North Campus Faculty Housing – Phase I
Project No. FM 100029L/ 986305
Addendum No. TWO

ADDENDUM NUMBER TWO

NOVEMBER 4, 2009

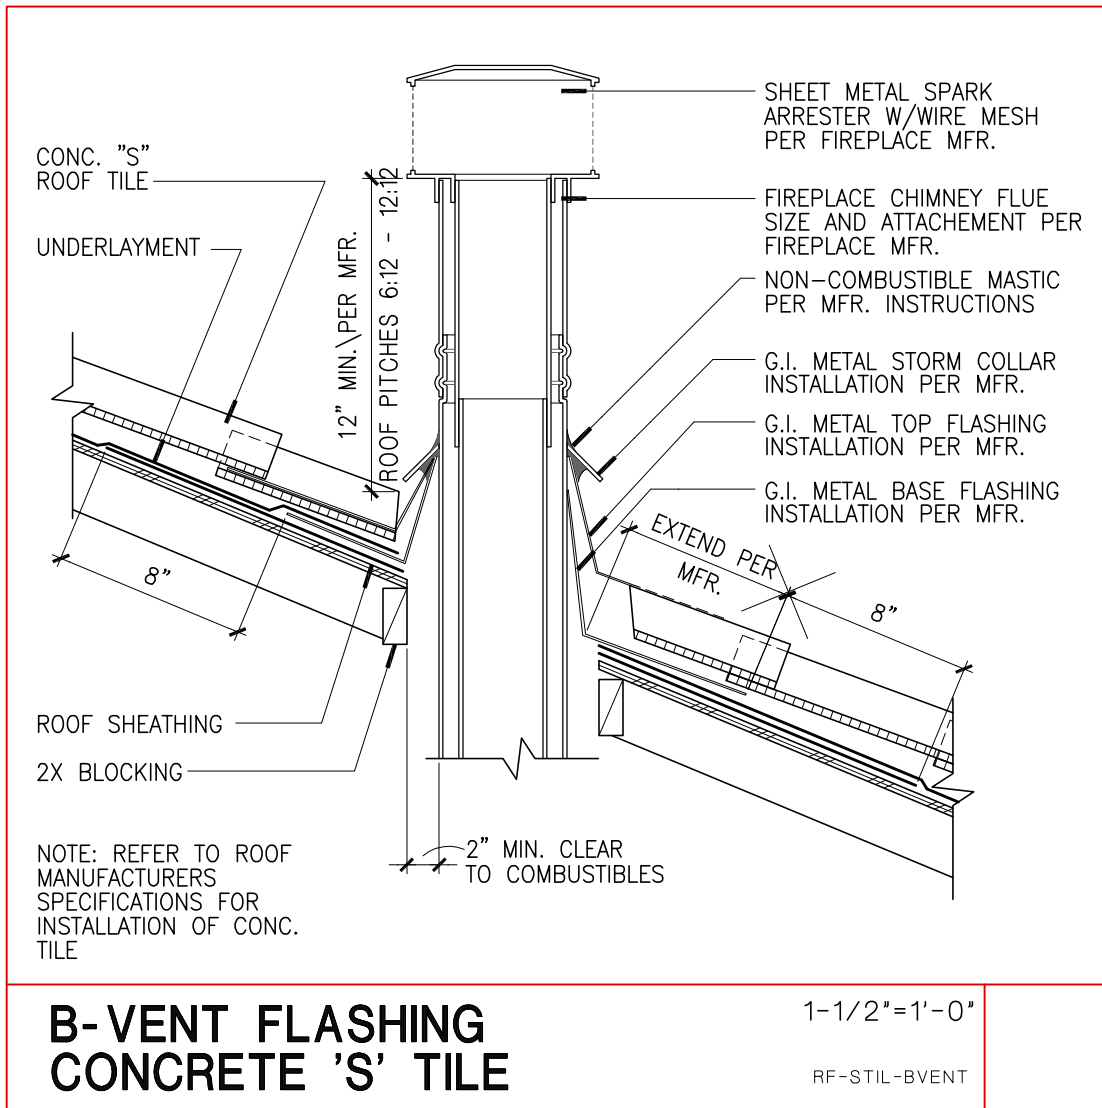
- 8 08 Tendon Anchor dated 10/28/09; replaces detail 4 on Sheet SD1-0

SKETCH
No. 05

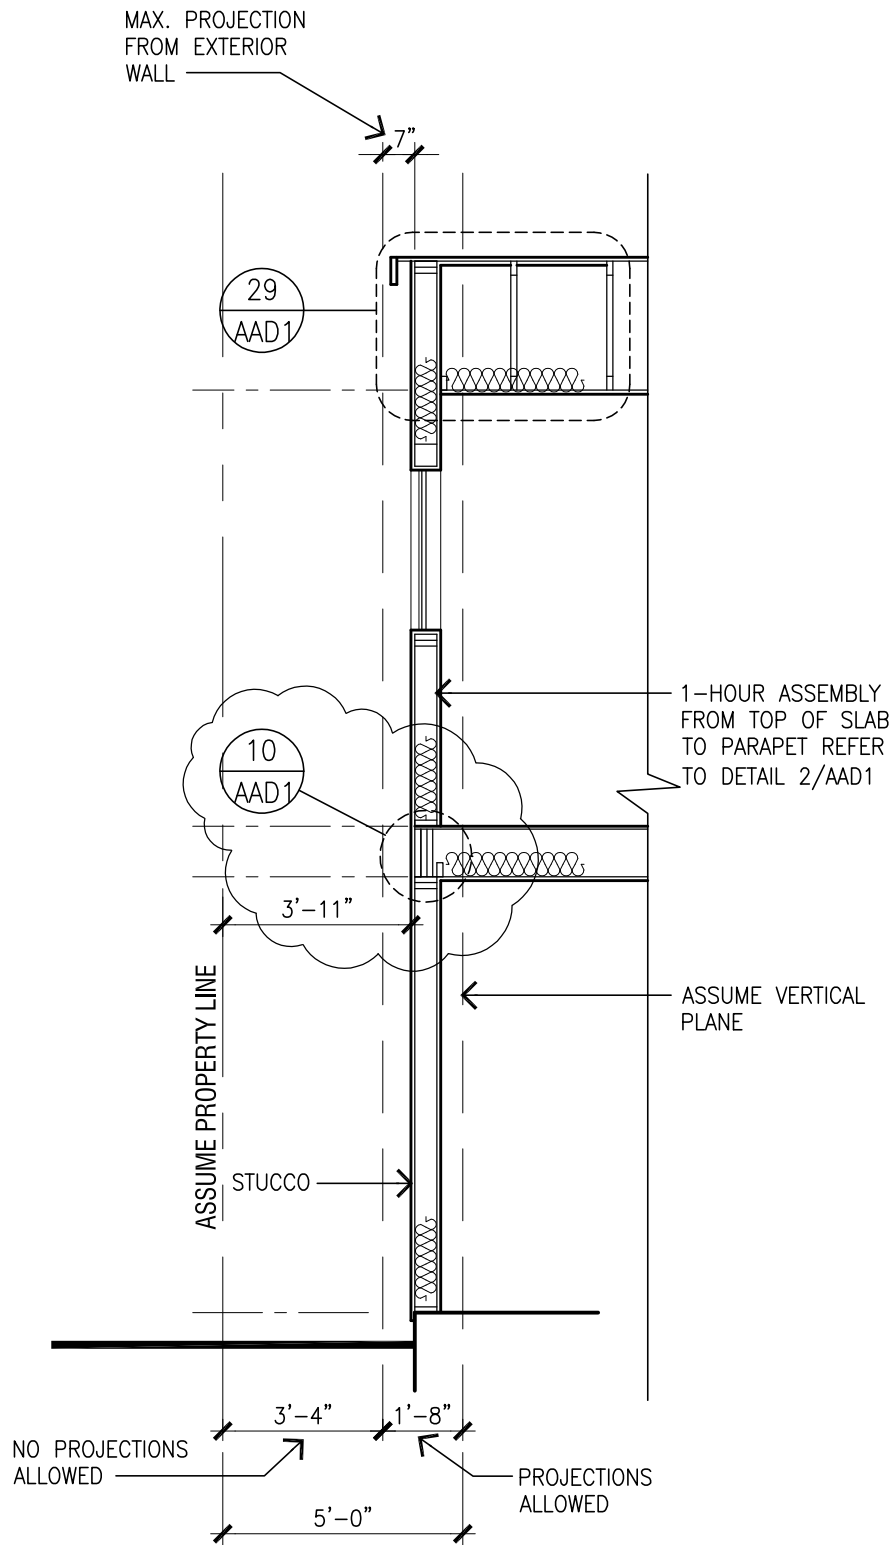
1. Drawing Number A2.10, Buildings 9 and 10 Fire Separation Distance Justification Partial Section – ‘B’ @ Building 9 Only

“1) Refer to Detail 10 on Sheet AAD1 for floor/ceiling assembly on the exterior wall condition. Reference Sketch 03 thru Sketch 06.”

- 5 05 Detail 10/AAD1 Call-Out Location at A2.10 dated 10-26-09

PARTIAL SECTION - 'C'

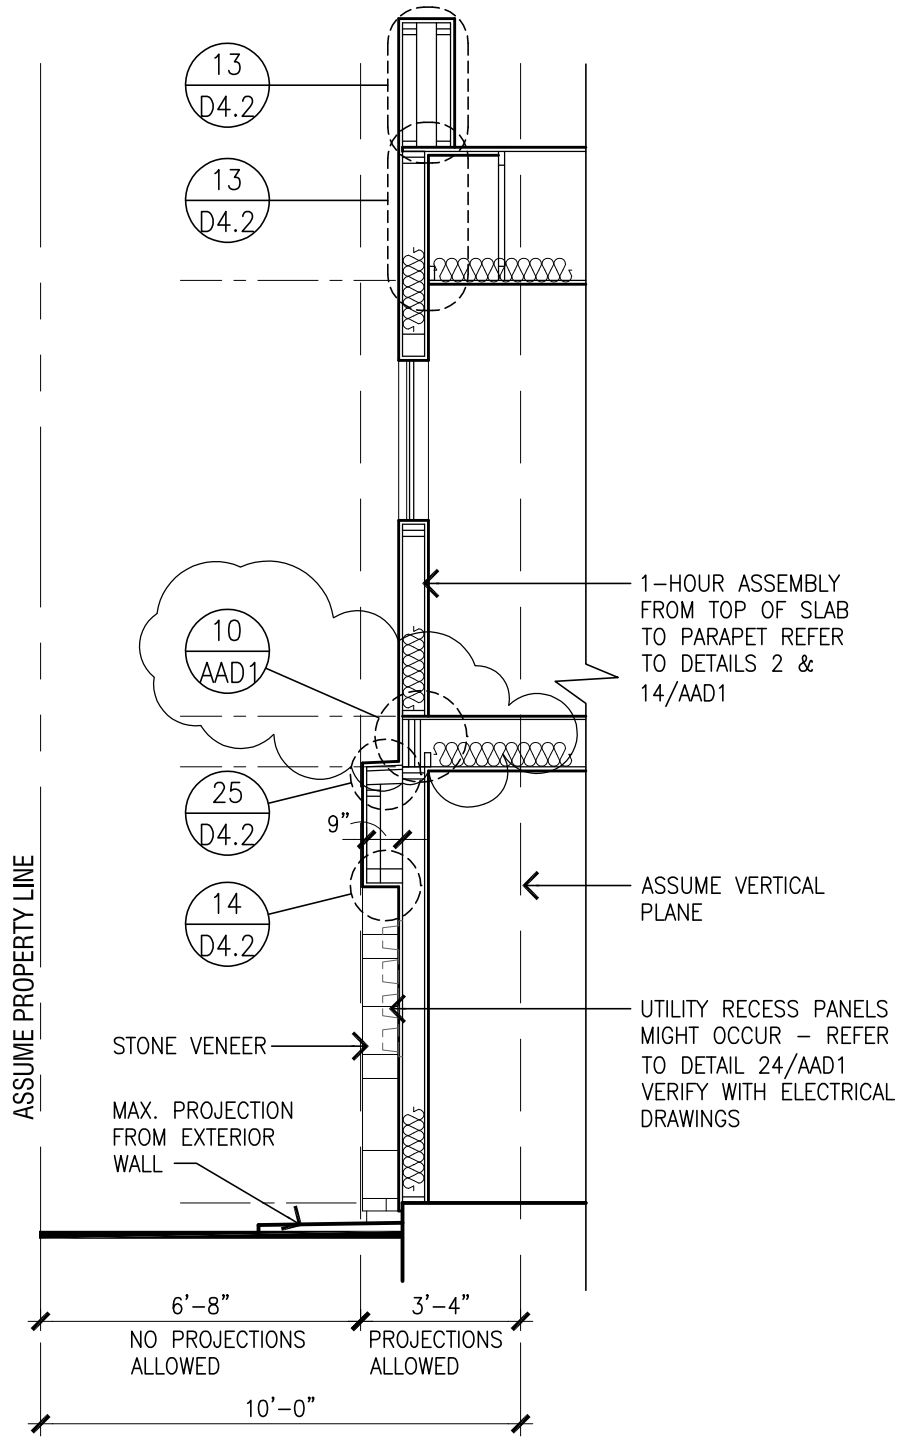
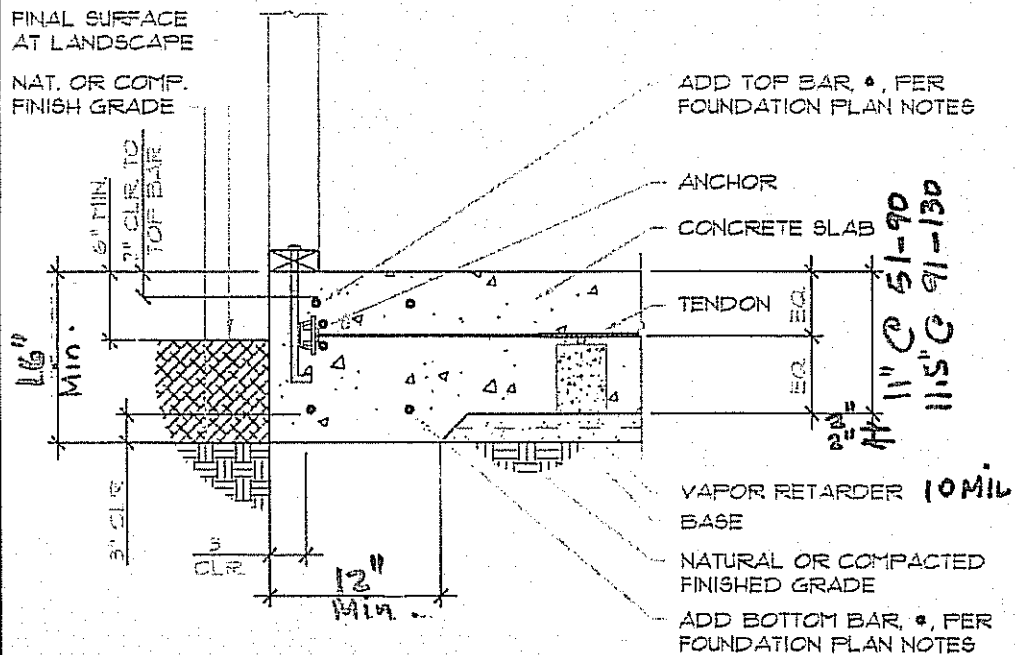
2. Drawing Number A2.11, Buildings 10 and 11 Fire Separation Distance Justification Partial Section – ‘C’ @ Building 11 Only

“1) Refer to Detail 10 on Sheet AAD1 for floor/ceiling assembly on the exterior wall condition. Reference Sketch 03 thru Sketch 06.”

- 6 06 Detail 10/AAD 1 Call-Out Location A2.11 dated 10-26-09

REPLACE DETAIL 11 ON SHEET SDI.0
 DATE: 10/28/09 SKETCH NO.07

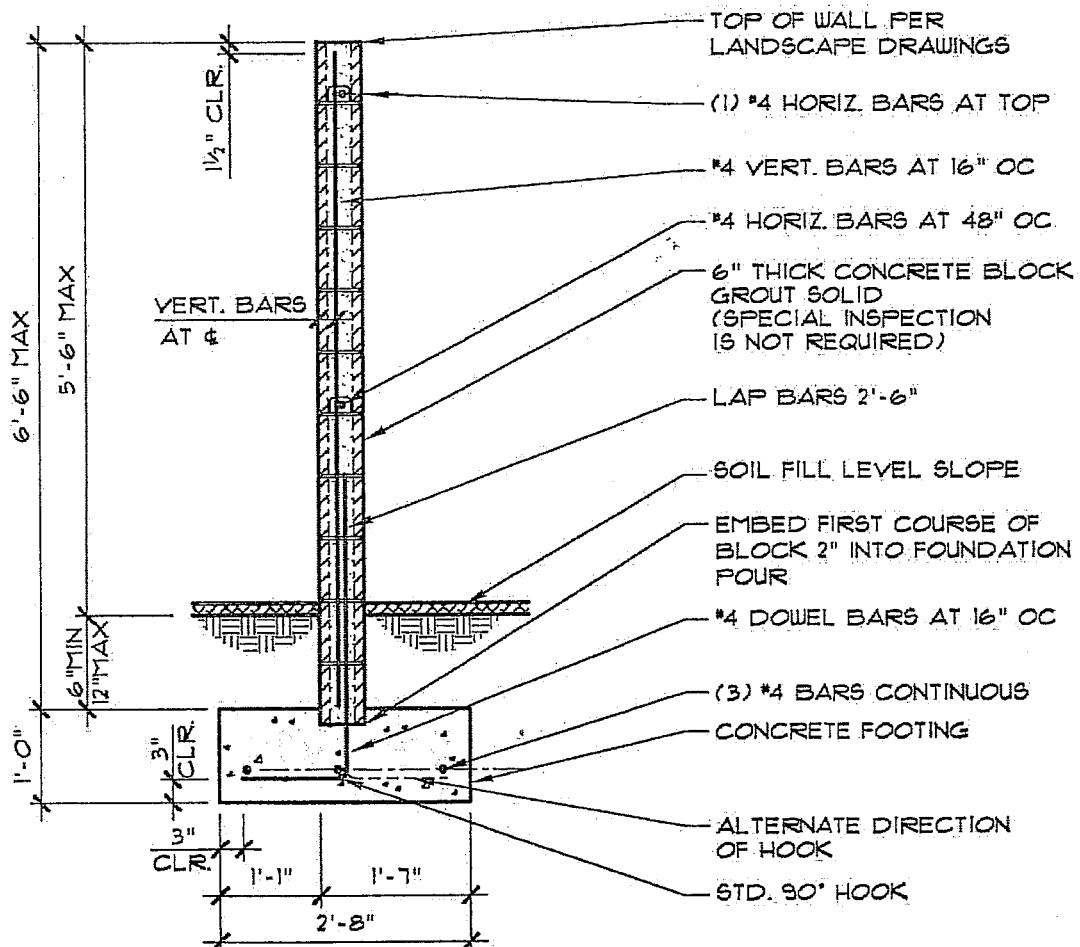
- 7 07 Exterior Footing Mat Foundation dated 10/28/09; replaces Detail 11 on Sheet SD1.0

EXPANSION	EXTERIOR FOOTING	SLAB
51-90	12x16 With 2#4 top, 2#4 bott.	11"
91-130	12x16 With 2#4 top, 2#4 bott.	11.5"
Vapor barrier min 10 mil		
Sand 2 inches of sand above and 2" below vapor barrier, min of 4 inches total.

MASONRY WALL (6/LCD-2)

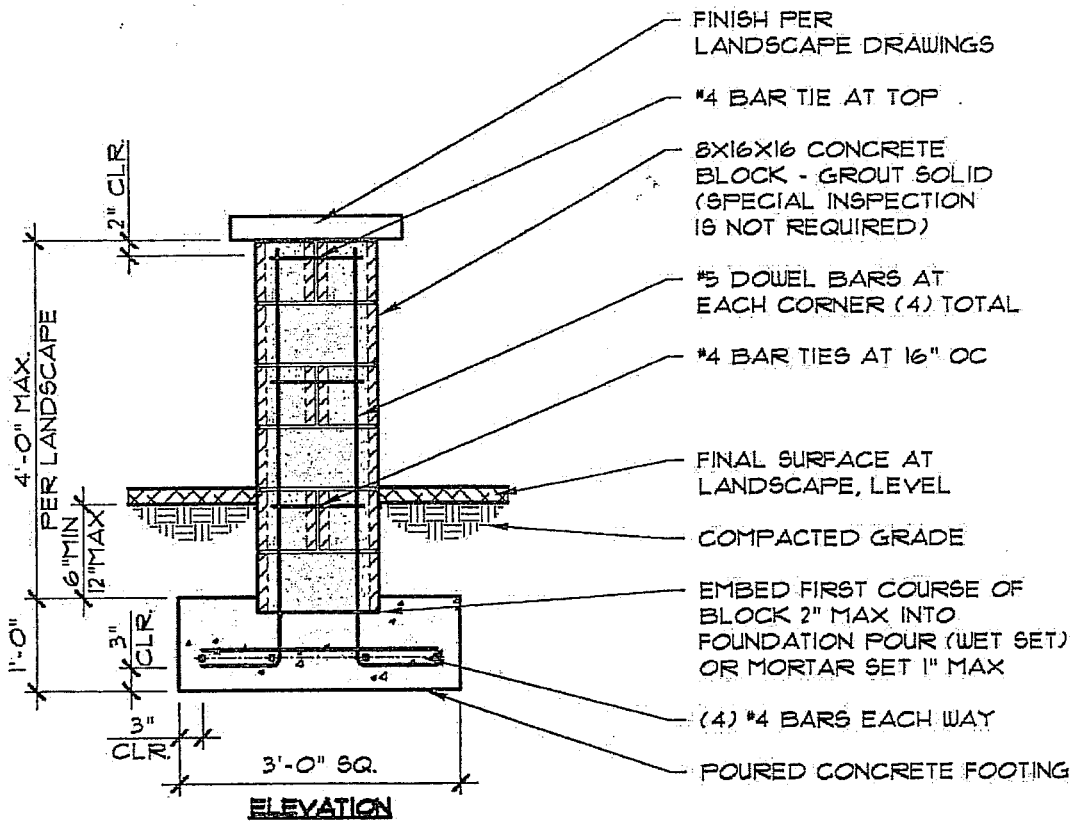
- 9 09 Masonry Wall dated 11/04/09; supplemental structural information for Detail 6 on Sheet LCD-2

16" PILASTER (2/LCD-2)

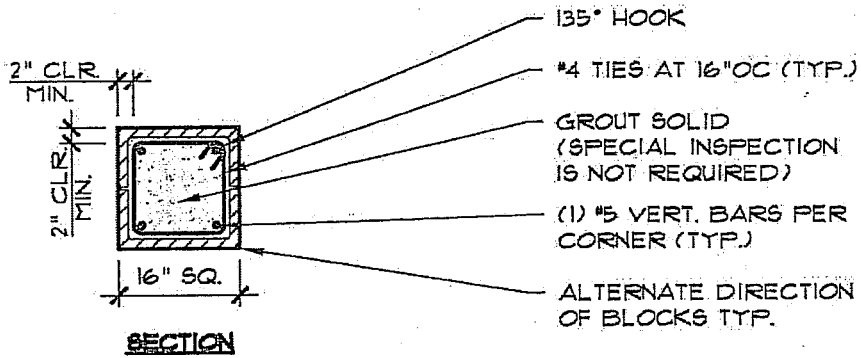
- 10 10 16" Pilaster dated 11/04/09; supplemental structural information for Detail 2 on Sheet LCD-2
